## KENAITZE INDIAN TRIBE REQUEST FOR PROPOSAL

### Sump Catch Basins Dena'ina Wellness Center Question and Answers

Issued: 2-9-2024

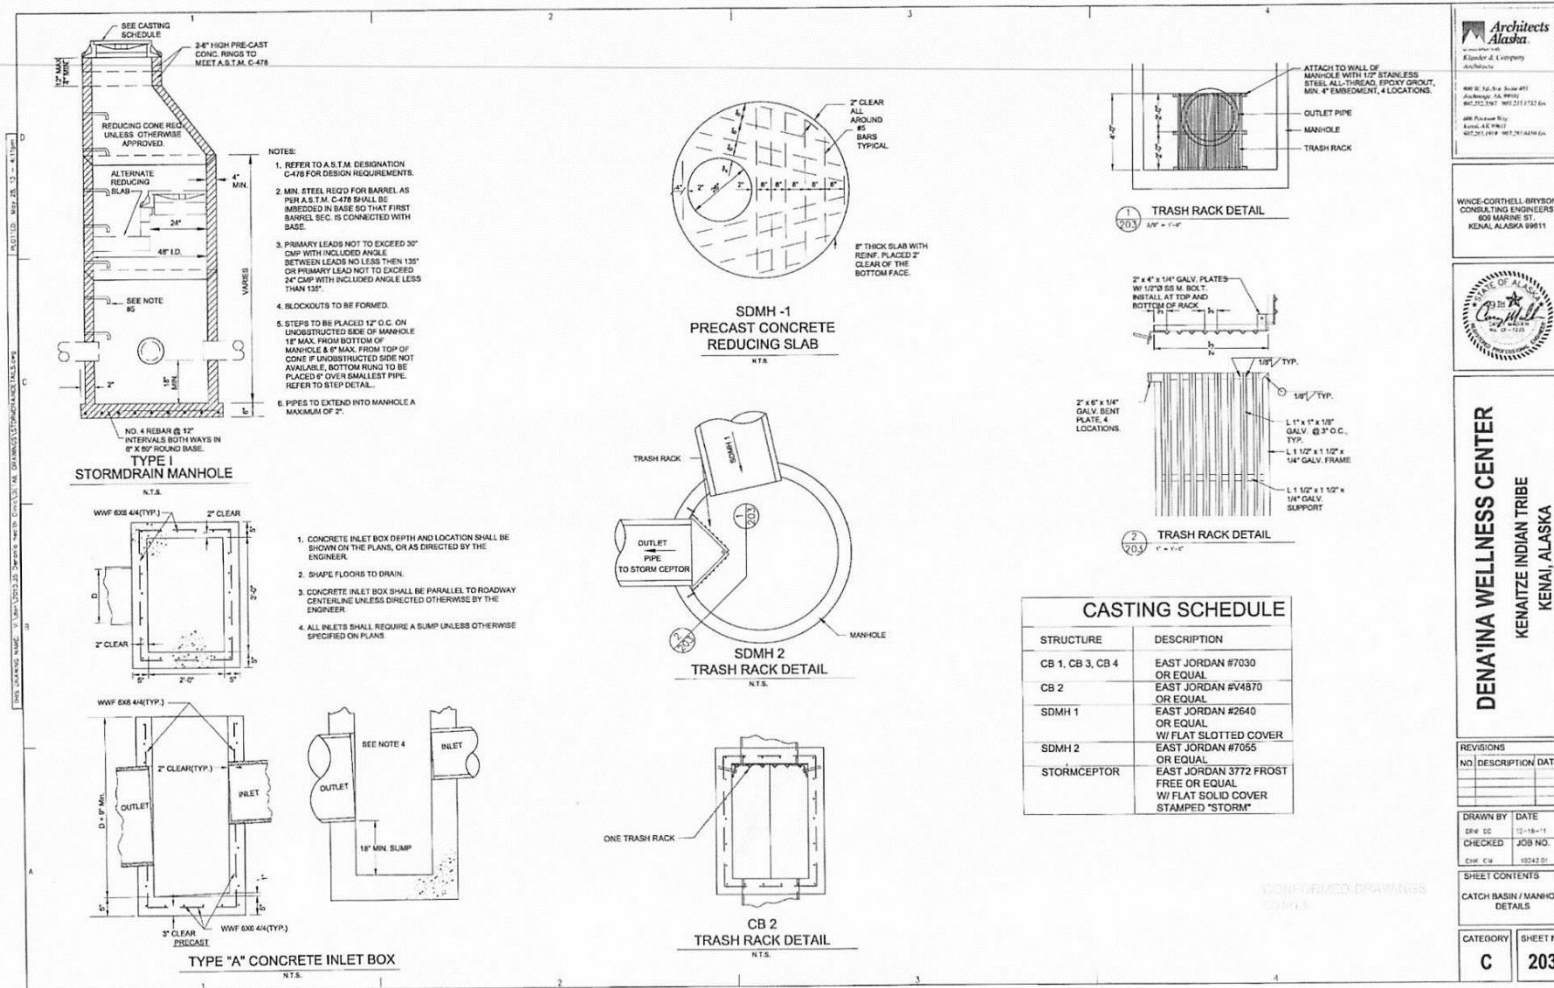
1. I noticed in Section 5, right before Section 5.1, that it says that work must be done on nights and weekends. Is there any way that can change? I ask for two reasons. One is that outdoor demolition work of this nature is generally quite noisy. The residents who live near your center will not be very happy if it is done at night. My other reason is that the concrete companies do not deliver at night. I'm pretty sure that they do not do weekend deliveries either.

We understand that some completion work will have to be done during normal operating hours. We will need to be mindful of how it impacts clinic staff and Un'ina.

The work will need to be done in sections.

Back parking lot –

Front parking lot –

Drive through drain –

We will be flexible when we can be.
